COLBEA ENTERPRISES, LLC SITE PLAN

SP# 12-25

STAFF REPORT

February 26, 2026

SITE TRIP ASSIGNMENT
 PM Peak Hour

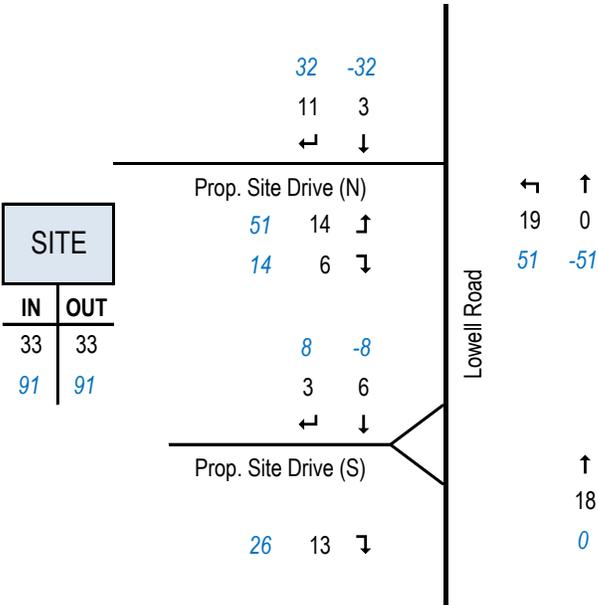
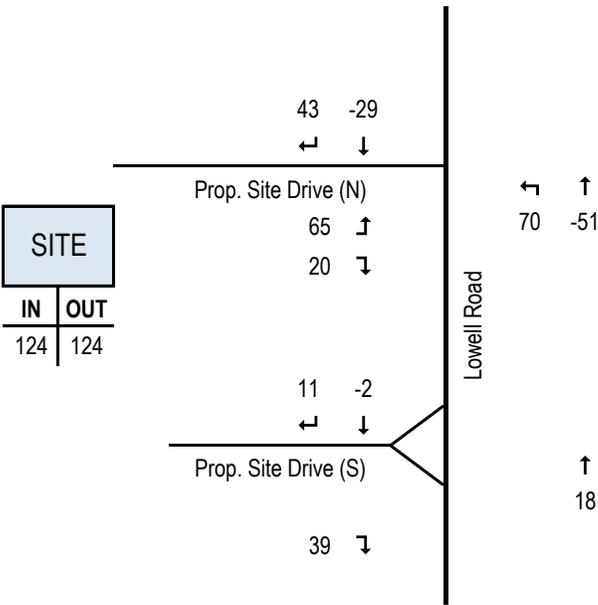
At driveways – the distribution was updated to move all left turns to the full driveway. See the following updated distribution diagrams.

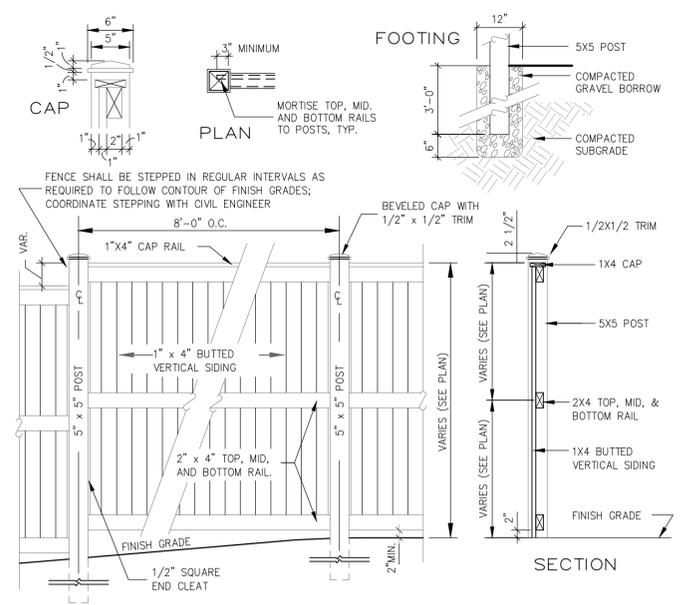
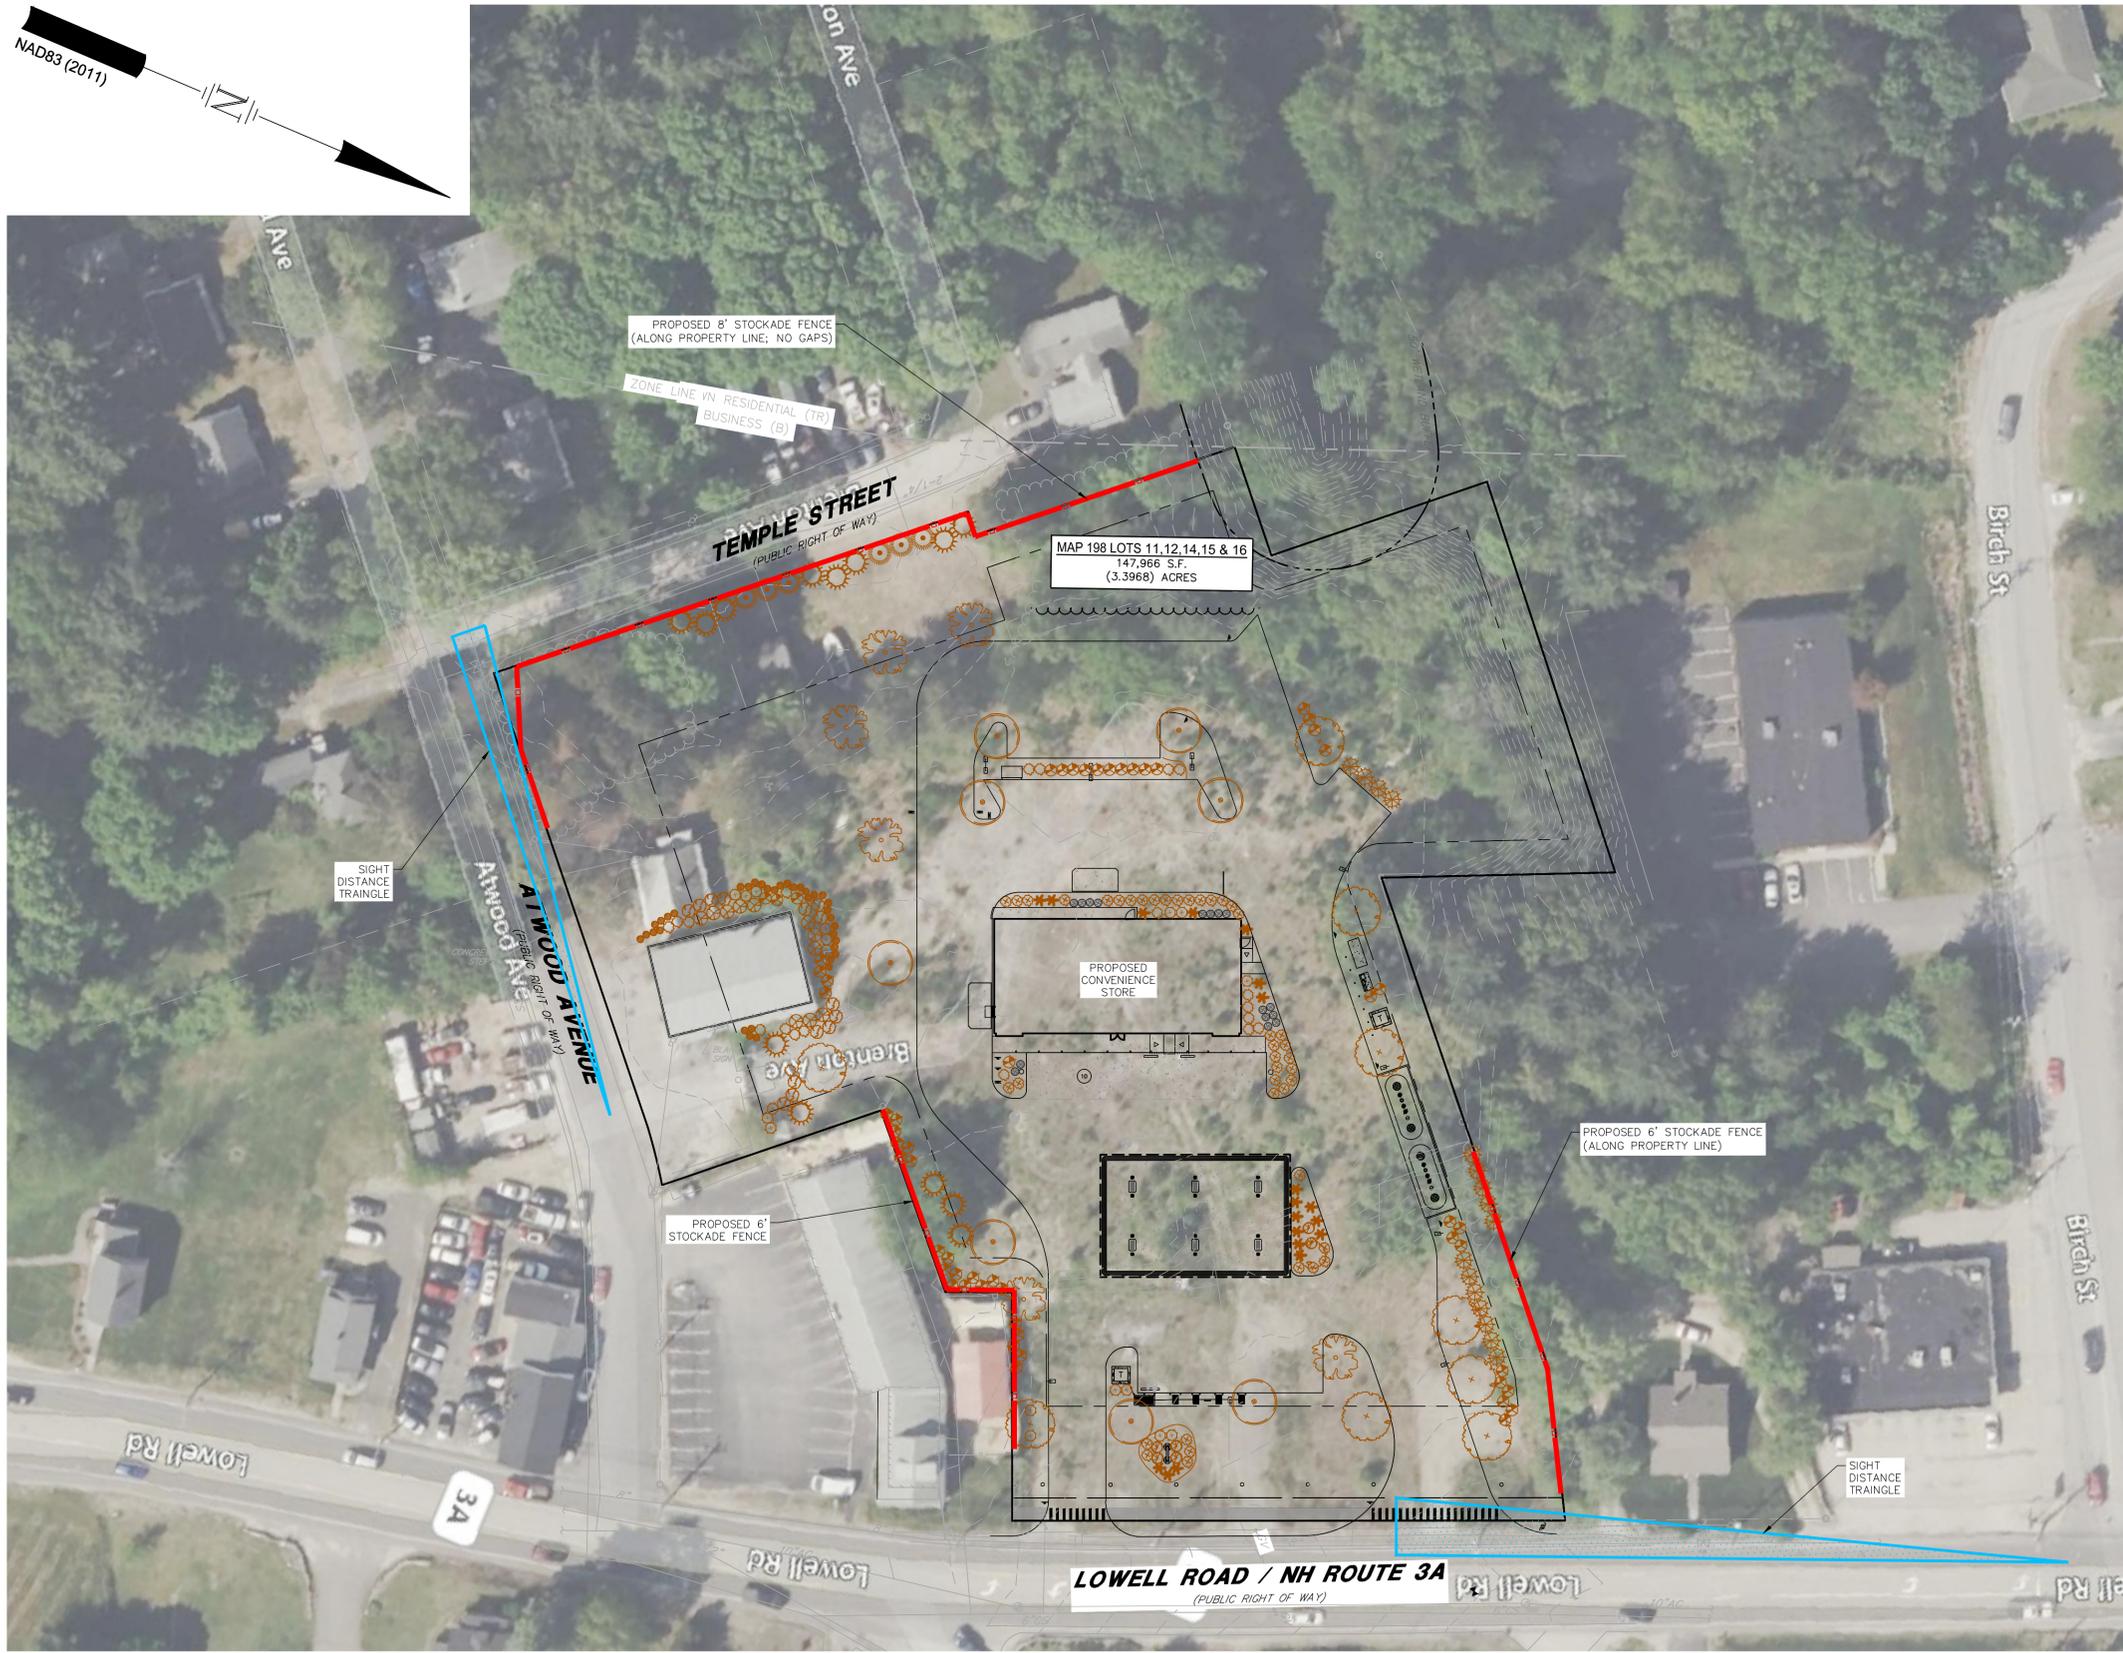
a. The applicant has revised the plans to eliminate light trespass. The applicant should review the revised light pole locations because it appears there is some conflict with proposed trees on the landscaping plan.

i. The location of light poles has been included on the Landscape Plan. Light pole and planting locations have been adjusted slightly to eliminate conflicts. All lighting and landscape requirements are still met.
